# PARTS & SERVICE NEWS

REF NO. AA01073

- SUBJECT:** CRACKS IN 930E-1 FRONT WHEEL HUBS (EG7682) FOR 57 INCH TIRES AND RIMS
- PURPOSE:** To inform the field of possible modifications or replacements needed in the 930E-1 wheel hubs.
- APPLICATION:** Komatsu 930E Dump Trucks A30002 - A30097, A30099, A30101 - A30120
- FAILURE CODE:** 2A80HA
- DESCRIPTION:** Modification or replacement of cracked front wheel hubs (EG7682).

FIGURE 1. FRONT WHEEL HUB

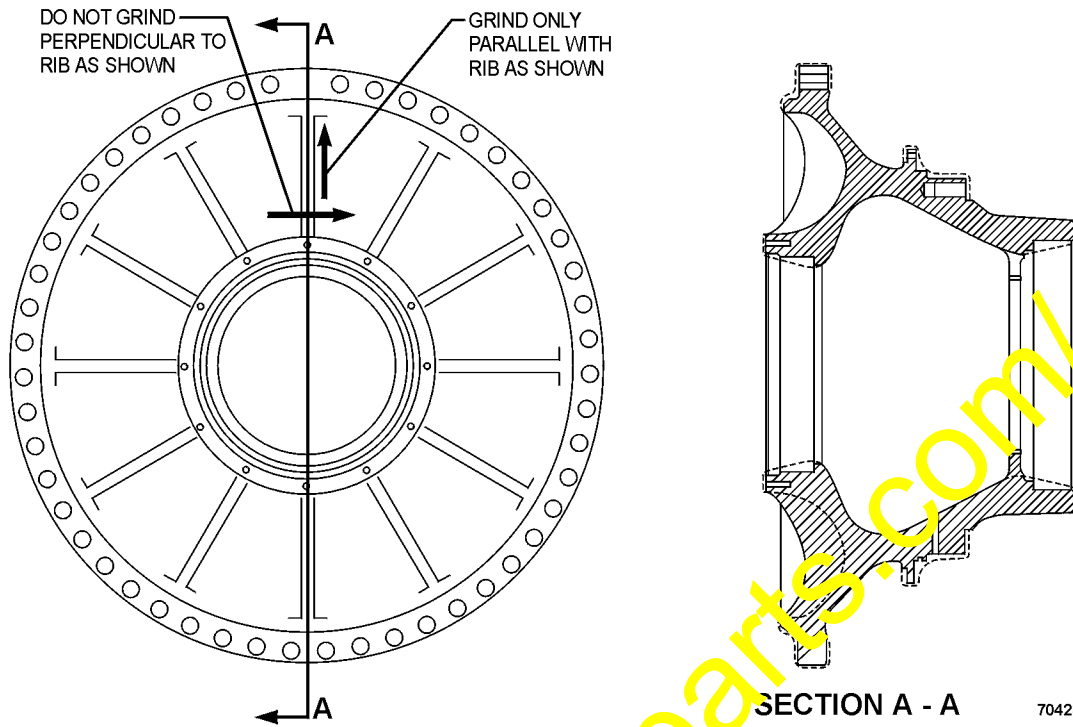
Cracks have been reported in the ribs of some front wheel hubs (EG7682). This problem has not occurred on 930E-2 wheel hubs which uses a ribless design. Depending on the number of ribs that are cracked and on the depth of the cracks, it may be possible to repair a front wheel hub.

A front wheel hub must be replaced if any of the following conditions are true:

1. A crack in a rib is more than 1.0 inch (25.4 mm) deep.
2. Cracks are found in four or more ribs.
3. A crack is found in a location other than a rib.

If cracks are found in fewer than four ribs, it may be possible to remove the cracks by grinding or by other mechanical means. No thermal process such as arc welding or torch cutting is permissible. It is permissible to remove a crack up to, but not exceeding 0.5 inch (12.7 mm) in depth by mechanical means. The crack may be ground out of the rib, thereby removing up to 0.5 inch (12.7 mm) of the rib.

Cracks that are deeper than 0.5 inch (12.7 mm) may not be repaired. If a crack increases to 1.0 inch (25.4 mm) in depth, the hub must be replaced. For further grinding instructions, refer to Figure 1.

*If cracks are removed by grinding, the direction of grinding should be radial, along the length of the rib, and must not be transverse, across the rib.*
